Service Bulletin

Bulletin No.: 17-NA-040

Subject: Brake Squeal or Squeak Noise Intermittently on Initial Brake Applies

3326987

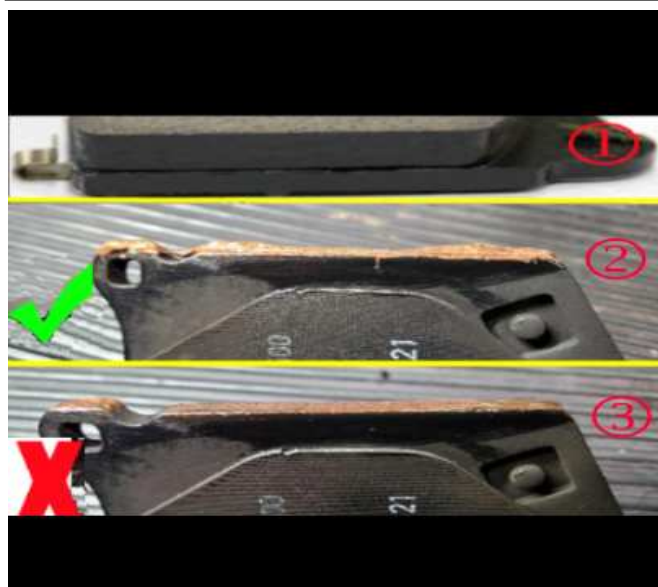
Apply a coat of copper paste to completely cover the pad backing plate abutments on each end. The paste should not extend onto the friction material. Follow the instructions listed below.

1. Remove the front disc brake pads. Refer to *Front Disc Brake Pads Replacement* in SI.
2. Using acrysol Kent Industries Part# P2005 or equivalent, wipe clean both ends of the abutment area on the front pads and calipers.
3. Apply approximately 0.10 g (0.0035 oz) of copper paste to each end of the disc brake pad abutments that contact the brake caliper bracket.

5926095

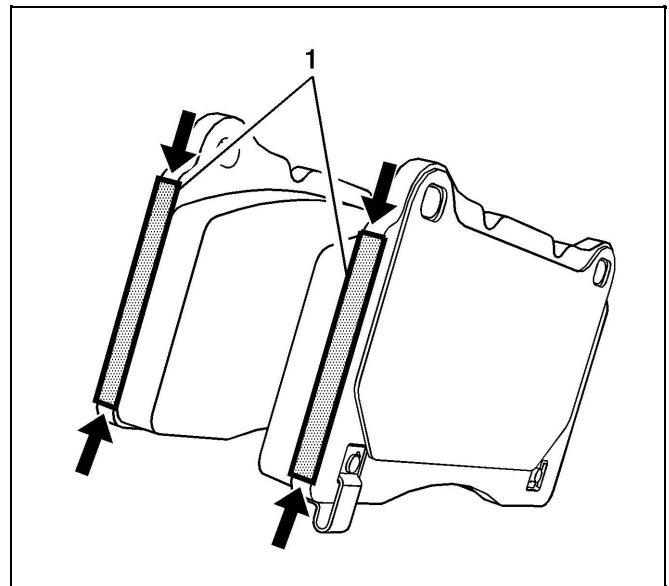
Note: Avoid a light apply of the paste as illustrated above.

3326987

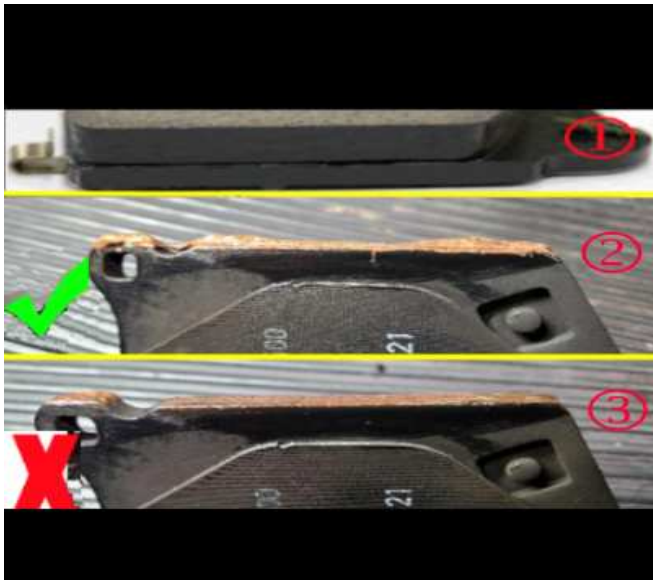
Important: Do not apply copper paste if the vehicle is equipped with copper free brakes RPO BCD.

1. Remove the front disc brake pads. Refer to *Front Disc Brake Pads Replacement* in SI.
2. Remove the rear disc brake pads. Refer to *Rear Disc Brake Pads Replacement* in SI.

5926095

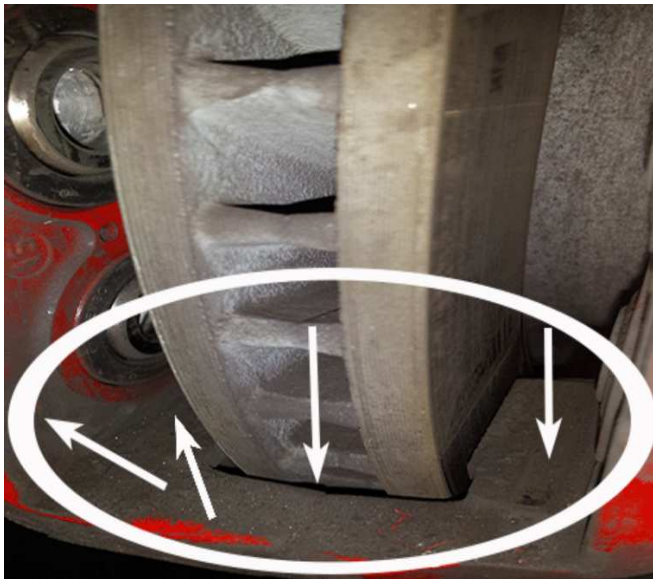
Note: Ensure that the ends of the brake pads have enough copper paste applied, if not, could result of the noise condition returning.

3. Using acrysol Kent Industries Part# P2005 or equivalent, wipe clean both ends of the abutment area on the front and rear pads and calipers.
4. Apply approximately 0.10 g (0.0035 oz) of copper paste to each end of the disc brake pad abutments that contact the brake caliper bracket.

4337633

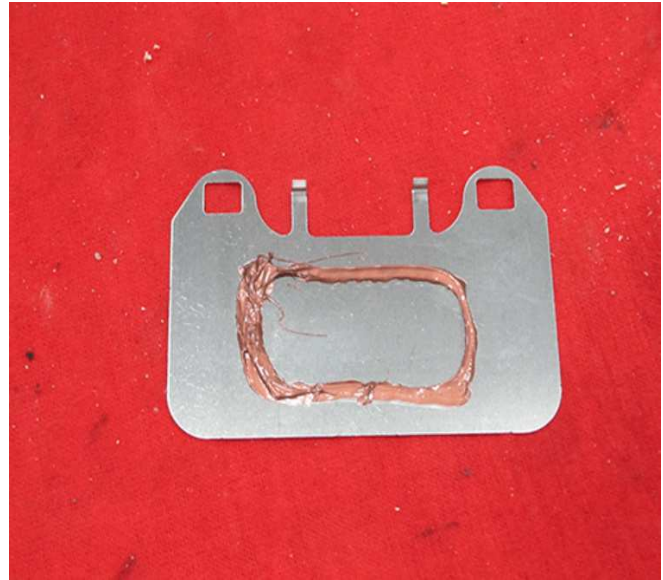
5. (Chevrolet SS Models Only) Apply a rectangular shape of copper paste in the center of the spacer before installing on the back of the pad.
